Re: 49 CFR Part 573; Recall of Mercedes-Benz S and CL-Class

Voluntary Recall Campaign MY 2000 - 2001 S and CL-Class Blower Motor Fuse Holder

Campaign No. 2004070010

SUBJECT: **MODELS 215/220**
MODEL YEARS 2000 THROUGH 2001
INSTALLATION OF BLOWER MOTOR WIRING HARNESS

Figure 1

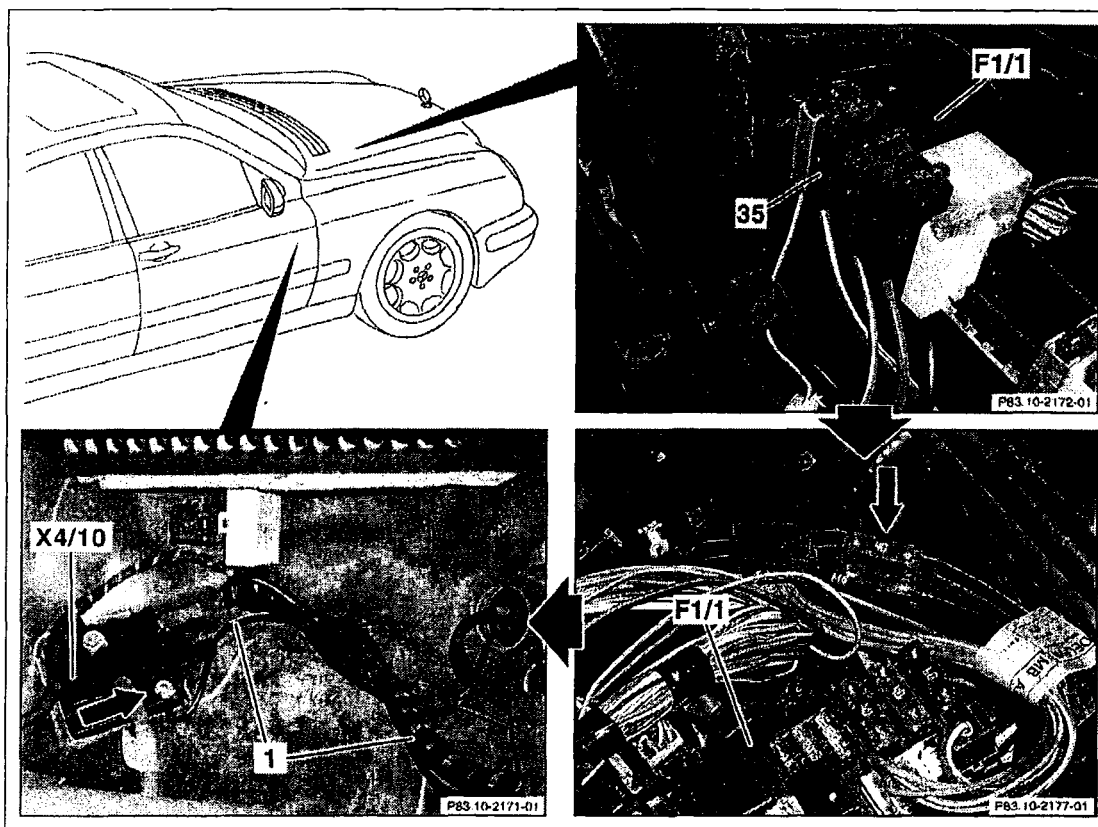
X4/10 Terminal block and fuse box, terminal 30
 F1/1 Right fuse box

Figure 2

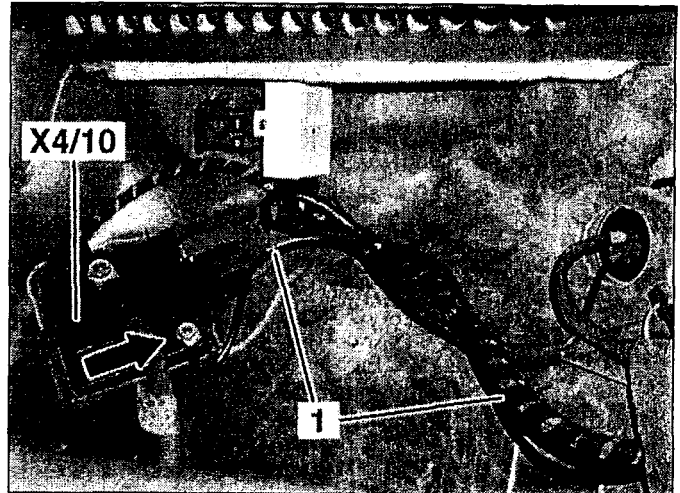
1. Route new interior blower motor wiring harness (1, Figure 2) with ring connector from the right fuse box (F1/1, Figure 3) into the right front footwell.

2. Route new interior blower motor wiring harness (1, Figure 2) along existing cables to the cable connector and fuse box terminal 30 (X4/10) and secure with cable ties.
3. Connect ring connector to designated M8 screw connection and torque M8 nut (arrow, Figure 2) to 9 Nm. (+ / - 1 Nm).

Figure 3

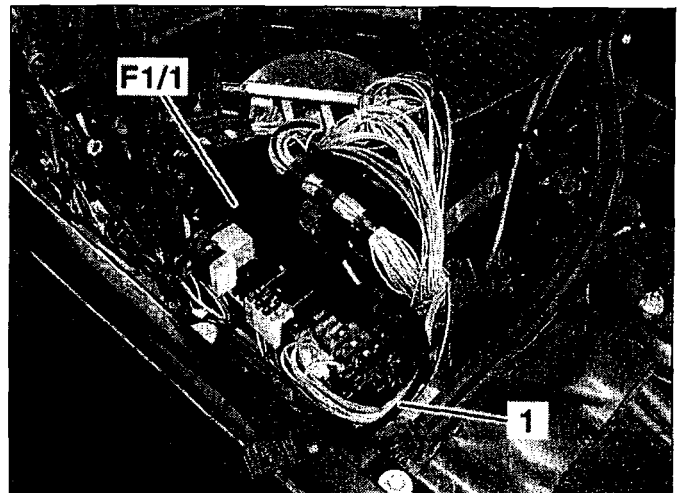
4. Remove brown fuse holder (fuse 35, Figure 4) with 40A fuse from the right fuse box (F1/1, Figure 3).
5. Unpin wire connector (with r/y wire, Figure 4) from brown fuse holder (35):
 - Remove fuse from fuse holder (35).
 - Unclip two outer locking tabs (A, Figure 4) furthest from the hinge (B) then partially pry open cover.
 - Unclip two outer locking tabs (C, Figure 4) closest to the hinge (B) then fully open cover to expose wire connectors.
 - Push the wire connector (with r/y wire) out from fuse side of fuse holder using special tools: Blade Handle W220 589 01 99 50 with blades W220 589 01 99 62 (both part of Wire Harness Kit W220 589 01 99 00 and W220 589 02 99 00).

Figure 5

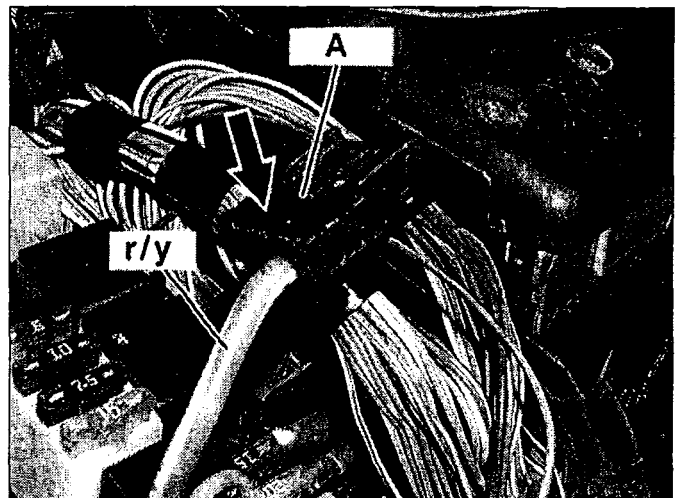
- The fuse holder (35) and fuse can be discarded.
 - r/y designates red/yellow wire.
6. Install unpinned wire connector (with r/y wire, Figure 5) into new harness connector (A):
 - Insert the unpinned wire connector (with r/y wire, Figure 5) into position 1 of the new harness connector (A).
 - Secure wire connector (with r/y wire) into position by locking closed the harness connector cover (arrow).

Figure 6

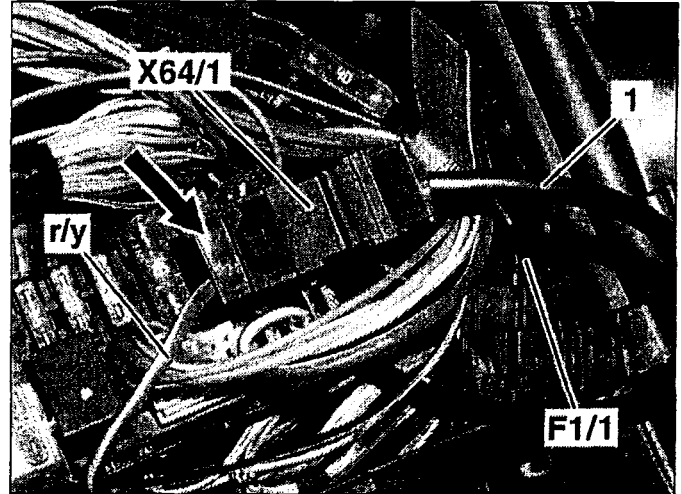
7. Connect the new harness connector (arrow, Figure 6) to the harness connector on the new blower motor harness wire (1) and place coupled connector (X64/1) below right front SAM in the right fuse box (F1/1).

Figure 7

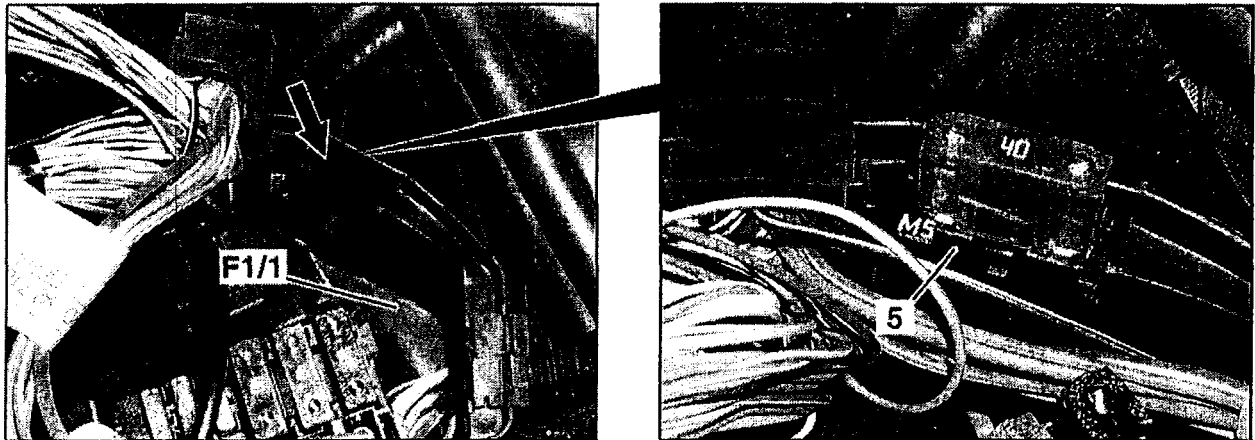
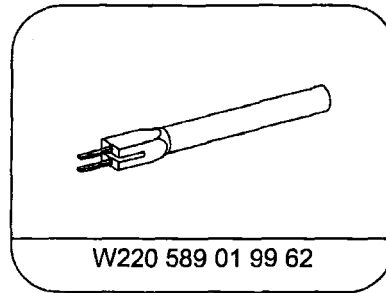
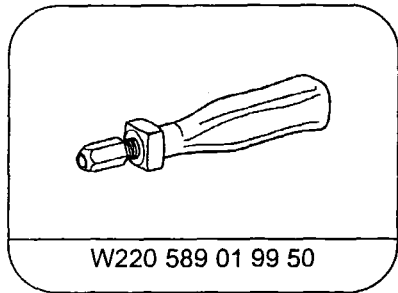
8. Install new maxi fuse holder (5, Figure 7) into grommet breakthrough (arrow) in right fuse box (F1/1).
9. Route interior blower motor harness below right front SAM in right fuse box (F1/1).
10. Reinstall right front SAM, reconnect wire harnesses to ME-SFI control module (if removed in step 4, subject A) and reassemble interior of vehicle in reverse order.
11. Reconnect battery ground cable WIS: AR54.10-P-0003I.
12. Read fault memory and erase using Star Diagnosis.
13. Check operation of interior blower motor.
14. Affix fuse/relay label over area of fuse chart identifying location of fuse/relays in **right front** fuse and relay box (fuses 28-49).
Note: Fuse and relay chart is located in trunk under lug wrench (in tool kit).
15. Reinstall remaining parts in reverse order.
